NEW MEXICO
ENVIRONMENT DEPARTMENT

**RE: RESPONSE TO PUBLIC COMMENT AND APPROVAL WITH MODIFICATIONS
SOIL-VAPOR SAMPLING AND ANALYSIS PLAN FOR THE U. S. DEPARTMENT
OF ENERGY/SANDIA NATIONAL LABORATORIES' MIXED WASTE
LANDFILL
SANDIA NATIONAL LABORATORIES, EPA ID NM5890110518
HWB-SNL-05-025**

**SUBJECT: NOTICE OF APPROVAL AND RESPONSE TO PUBLIC COMMENT ON
SOIL-VAPOR SAMPLING AND ANALYSIS PLAN FOR THE
U. S. DEPARTMENT OF ENERGY/SANDIA NATIONAL
LABORATORIES' MIXED WASTE LANDFILL**

Soil Gas VOC, Tritium, and Radon Sampling Locations, Mixed Waste Landfill

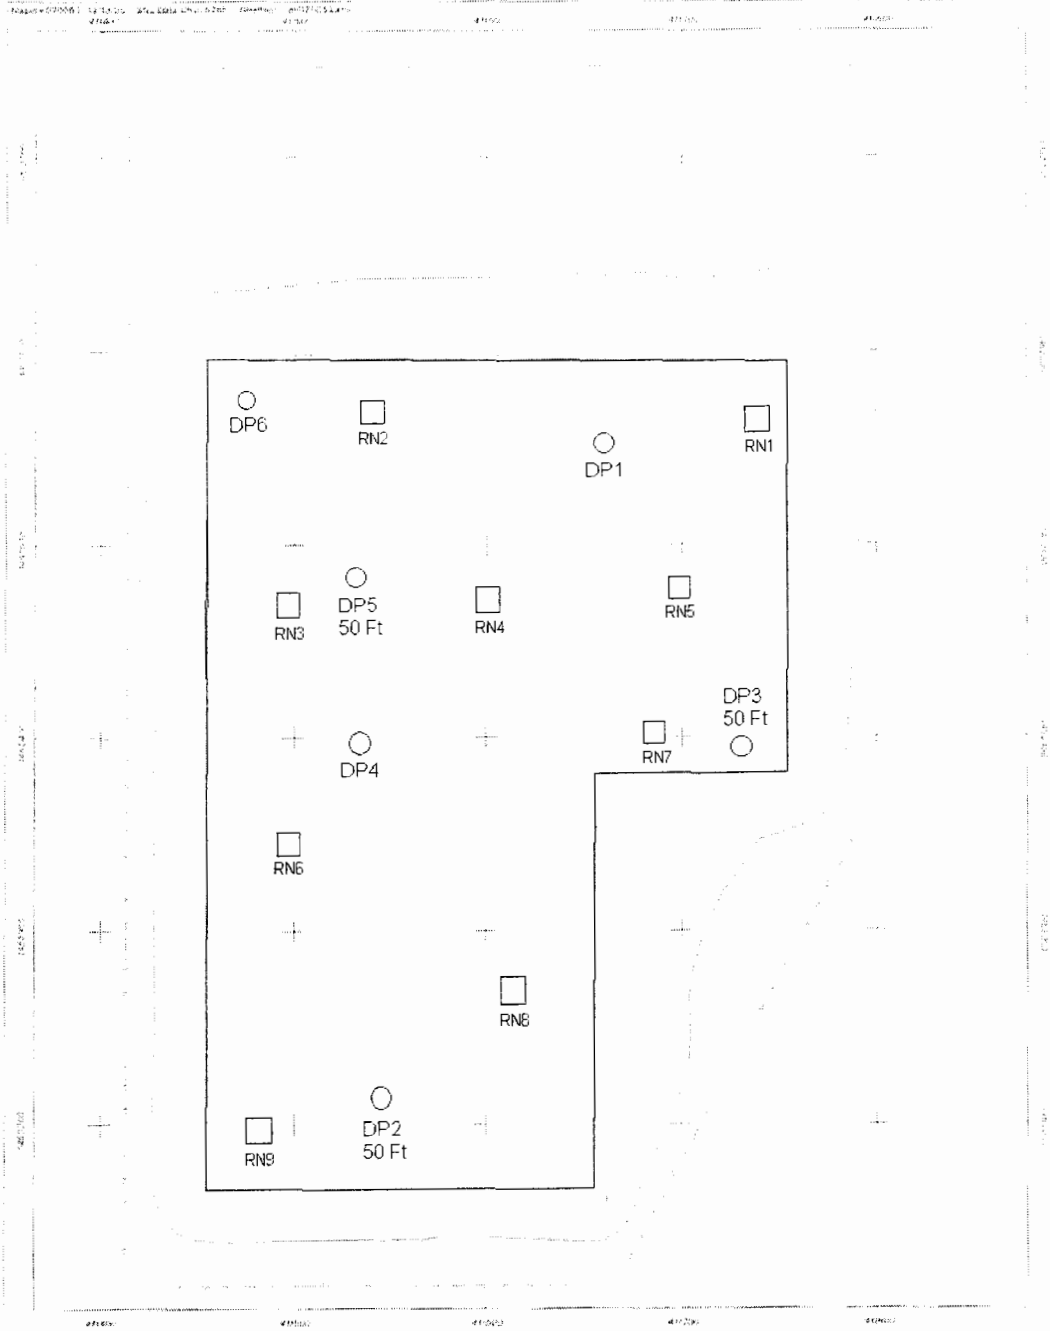
1. Six boreholes for the collection of soil gas and soil samples shall be drilled at the locations shown on the enclosed map (at locations DP1-DP6). Two other boreholes (DP7 and DP8), planned for background locations southwest of the landfill, may be drilled at the background locations as proposed in the SV SAP.

Soil-gas and soil samples from DP1-DP8 are to be analyzed for volatile organic compounds (VOCs) and tritium, as appropriate, as described in the SV SAP. As shown on the enclosed map, the locations for DP4 and DP5 shall be the same as those shown on Figure 2-1 of the SV SAP; the rest of the boreholes, DP1-DP3 and DP6, are to be moved to different locations (see the enclosed map) because of the heterogeneous nature of waste placed into the MWL. To protect workers, the borehole locations for DP1-DP6 may be adjusted by a maximum of 20 feet in any horizontal direction to avoid drilling directly through waste buried in the MWL.

2. Soil-gas and soil samples from boreholes DP2, DP3, and DP5 shall be collected at depths of 10, 30, and a minimum of 50 feet. Samples from all other boreholes shall be collected at depths of 10 and 30 feet.

4. Nine radon detectors (RN1-RN9) shall be deployed at the locations shown on the enclosed map. These locations were selected, in part, based on the highest flux rates for radon as determined in the 1997 survey, and do not include the two background locations proposed in the SV SAP. The locations for RN1, RN3, RN4, RN5, RN6, RN7, and RN8 correspond to locations 30, 5, 8, 44, 13, 64, and 18 of the 1997 survey, respectively. The locations of RN2 and RN9 are new.
